RE: Resubmitted TEDS Exception from Minimum Access Spacing at 670 W. Gunnison Avenue

DESIGN EXCEPTION #DE25-02

RE: Appeal of the Denial of an Exception from Access Spacing Criteria at 670 W. Gunnison Avenue

Title Heading: West Gunnison Office/Warehouse
Location: 670 West Gunnison Ave.
Petitioner: Marty Kolonel/Koloha Investments LLC
P.O. Box 882076
Steamboat Springs, CO 80488
Representative: Randy Taylor

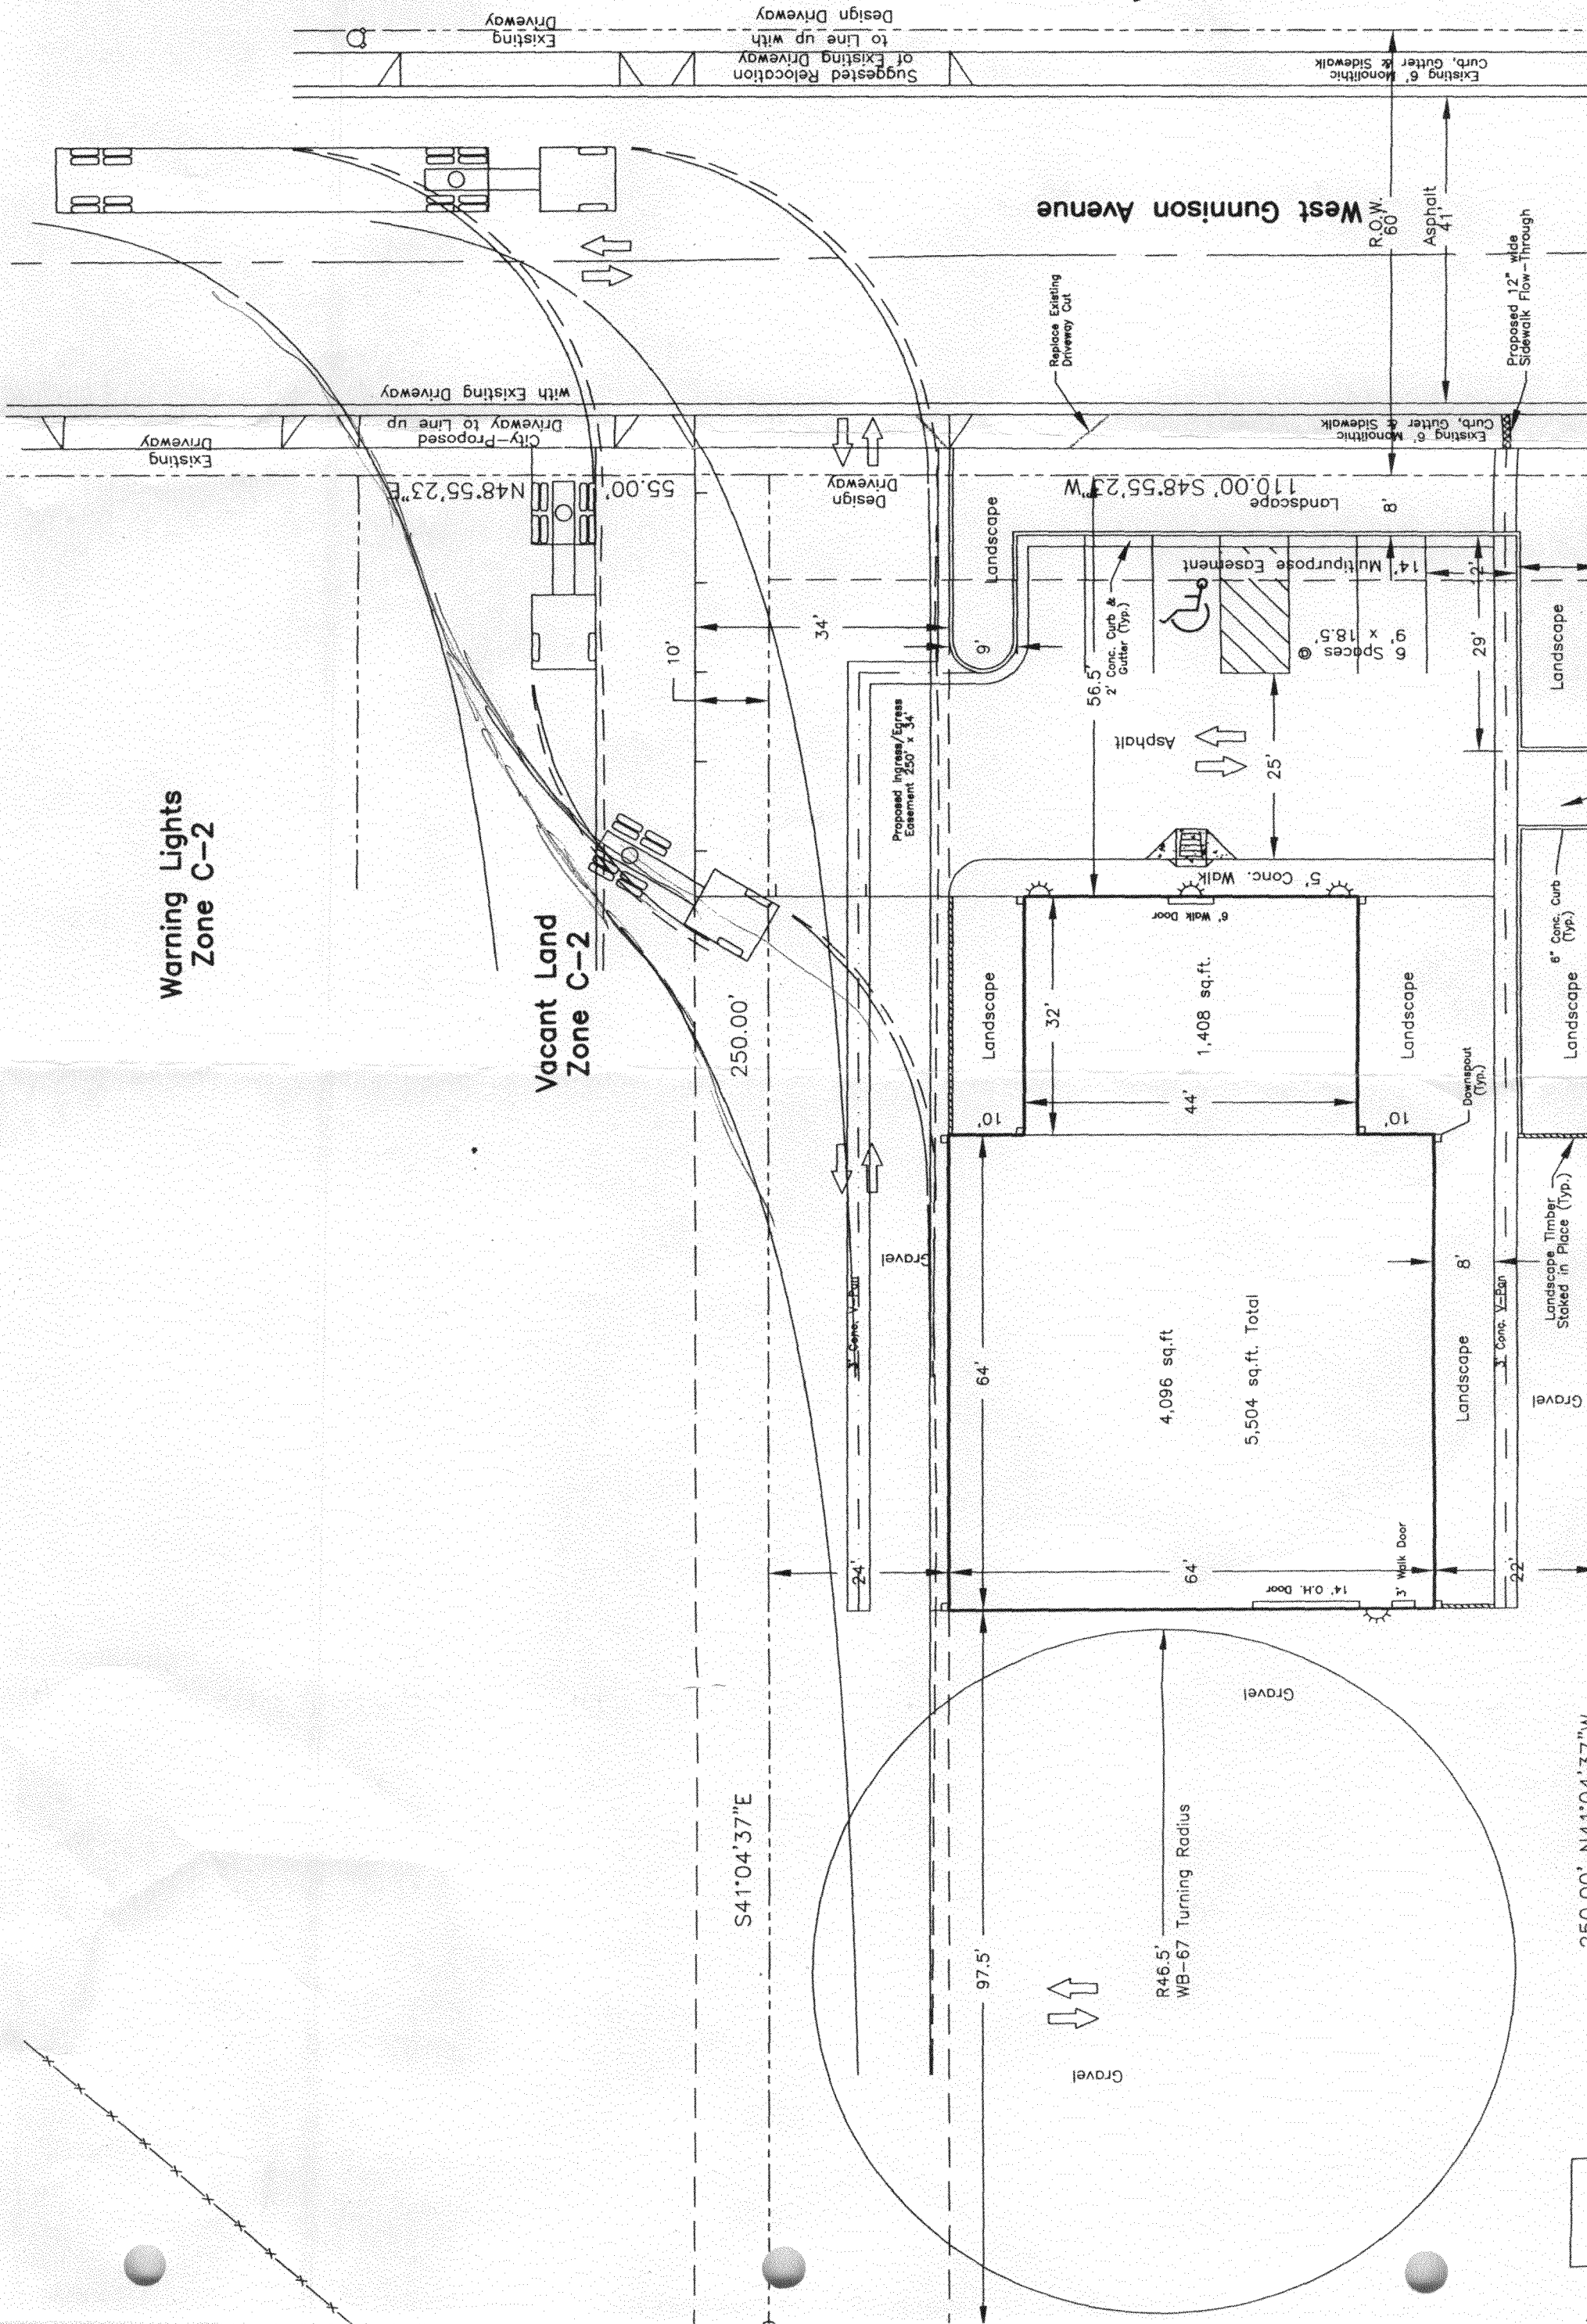
Applicant is planning to construct a building at the above property. They are proposing to construct one driveway along the north side of W. Gunnison Avenue 137 feet west of one existing driveway and 92 feet east of another. There is another access on the opposite side of West Gunnison located about 47 feet east of the proposed new driveway. The applicant proposes to make this new access available to the last remaining vacant property to use as a joint access.

Since there is not 150 feet between the driveways on either side, it appears that an exception to the TEDS may be in order. This is nearly the last property to develop in a neighborhood that was mostly constructed under a lesser regulation for access spacing. The prior development does not appear to provide any options that will fully comply with TEDS.

The applicant requests exception from Section 4.1.1, *Spacing*. Due to the configuration of driveways along both sides of West Gunnison, exception will also need to be granted from Section 4.1.2, *Offsets*.

There is another and perhaps better solution to the City's proposed solution to driveway spacing on West Gunnison, that is to allow the driveway for this project to be located as proposed and when the vacant property across the street is developed, require that they locate their driveway opposite the Koloha entrance. This would provide more spacing between the driveway for the vacant land and Warning Lights than currently exists and seems like a much better spacing than the one proposed by the City (92ft versus the current spacing of 45ft.).

Note that the proposed driveway has been widened to better accommodate anticipated truck traffic and a wider easement has been proposed to allow trucks to turn around and exit the property. This solution leaves more latitude in the final development of the remaining vacant lots along this section of W. Gunnison.

I recommend APPROVAL of the needed Design Exceptions to Sections 4.1.1 & 4.1.2 to allow a reduced spacing between the proposed driveway and other the existing driveways on the north and south sides of West Gunnison Avenue.
